# Coordinator-General's Change Report on the Supplementary Report to the Environmental Impact Statement dated March 2008

## Northern Pipeline Inter-connector Stage 1 Landers Shute to Morayfield

Released: 11 April 2008

**Figure 1 Proposed change involving a chemical dosing facility at the Landsborough Site**

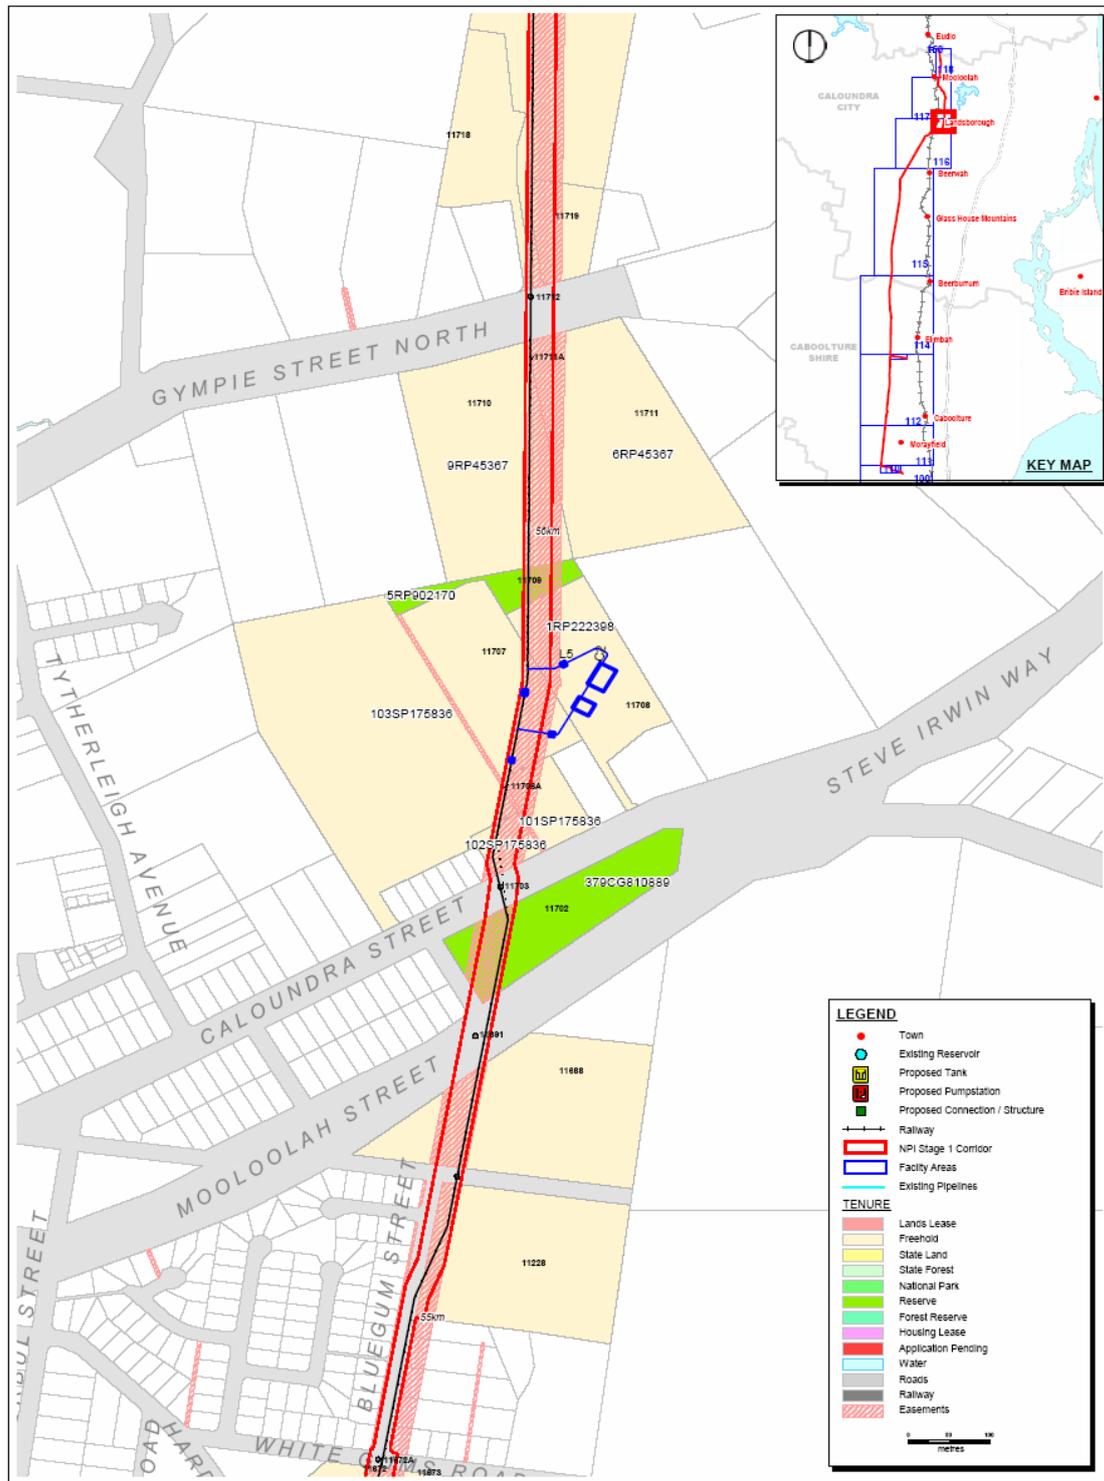
This report evaluates the environmental impacts of a proposed change to the Northern Pipeline Inter-connector (NPI) Stage 1 (“the Project”) in accordance with s.35I of the *State Development and Public Works Organisation Act 1971* (Qld) (SDPWO Act). The proposed change involves development of a chemical dosing facility on part of Lot 1 on RP222398 and Lot 103 on SP175836 adjoining Caloundra Street at Landsborough (“the Landsborough Site”). A locality map is provided as Figure 1.

The proposed change involves the development of a chemical dosing facility on private land on the Landsborough Site (“the Proposed Change”). The size of the chemical dosing facility is approximately 75 m by 25 m. The size of the facility would not increase to accommodate future bulk water flows, but could be modified with additional internal modules and storage units.

Due to the location of the Landsborough Site to nearby water courses and Ewen Maddock Dam, along with the relative low lying nature of the area, the chemical dosing facility may be impacted by flooding.

In providing comment on the SEIS March 2008, Council advised that in accordance with the *State Planning Policy 1/03 Mitigating the Adverse Impacts of Flood, Bushfire and Landslide* the chemical dosing facility would need to be above the Q200 flood level. LinkWater subsequently advised that the level of the chemical dosing facility is 35.8 m Australian Height Datum (AHD) and that the Q100 flood level derived from existing flood modelling is 28.01 m AHD. Further, LinkWater suggests that the Q200 flood level is likely to be around 28.15 m AHD and hence well below the level of the chemical dosing facility. LinkWater has given an undertaking to undertake more detailed modelling of the Q 200 flood level, however this is not expected until after the release of this report.

In the SEIS March 2008, LinkWater advised that the chemical dosing facility has been reconfigured to provide an additional buffer distance to Addlington Creek, which feeds into Ewen Maddock Dam.

In providing comment on the SEIS March 2008, Council requested that a different legal point of access to that proposed by LinkWater is required to the Landsborough Site. Council also requested that the findings of traffic modelling and the traffic control plans proposed by LinkWater are provided to Council for comment.

I find that the chemical dosing facility at the Landsborough Site would constitute a critical infrastructure facility as part of the SEQ water supply infrastructure. Consequently, the Landsborough Site should be assessed against a Q200 flood level to ensure its function is maintained in an extreme event, as set down in the *State Planning Policy 1/03 Mitigating the Adverse Impacts of Flood, Bushfire and Landslide*. I therefore make the following recommendation:

**LinkWater should undertake flood modelling and demonstrate that the chemical dosing facility will be located above the Q200 flood level, in accordance with *State Planning Policy 1/03 Mitigating the Adverse Impacts of Flood, Bushfire and Landslide*. The results from the modelling should be provided to the Sunshine Coast Regional Council before commencing development of the chemical dosing facility.**

**LinkWater should ensure that all surface water flows during construction and operation of the chemical dosing facility are directed to the existing sediment control pond within the proposed Addlington Industrial Park or a similar structure.**

**LinkWater should ensure that the legal point of access for the chemical dosing facility at the Landsborough Site meets the Sunshine Coast Regional Council's requirements.**

**Figure 2 Proposed pipeline in the existing power line easement near the junction with NPI Stage 2**

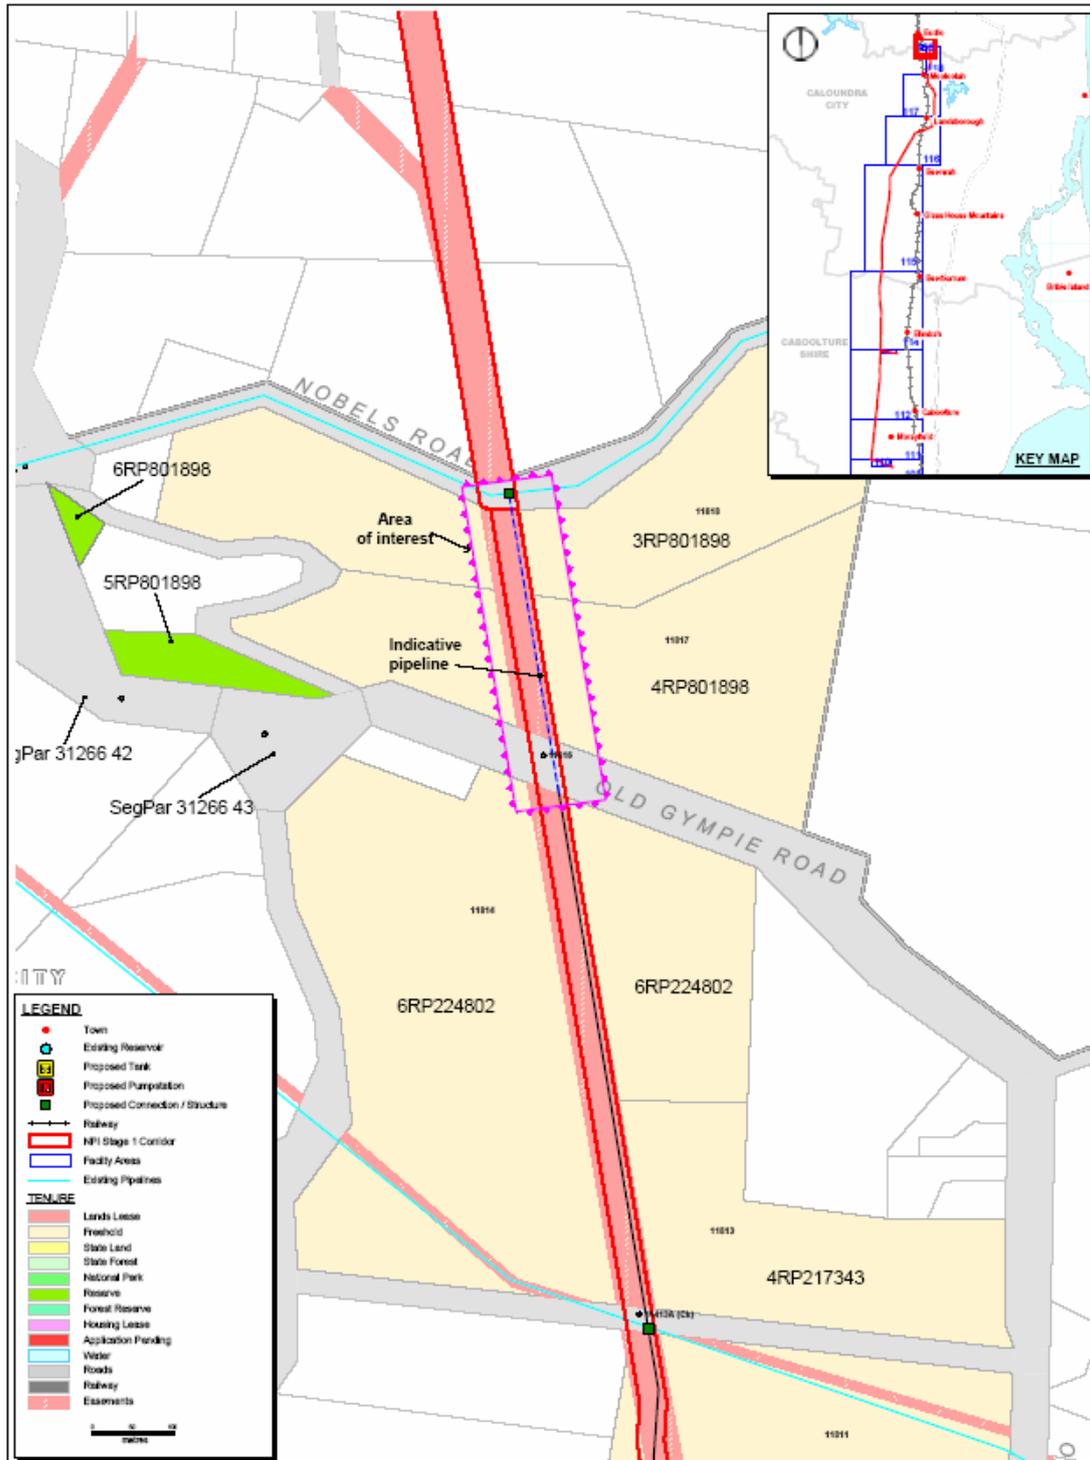
The report does not evaluate the construction of the pipeline within the power line easement near the junction with the Eudlo to Caloundra water pipeline on the northern end of NPI Stage 1, as this was evaluated in my report dated 10 October 2007. A locality map is provided as Figure 2.
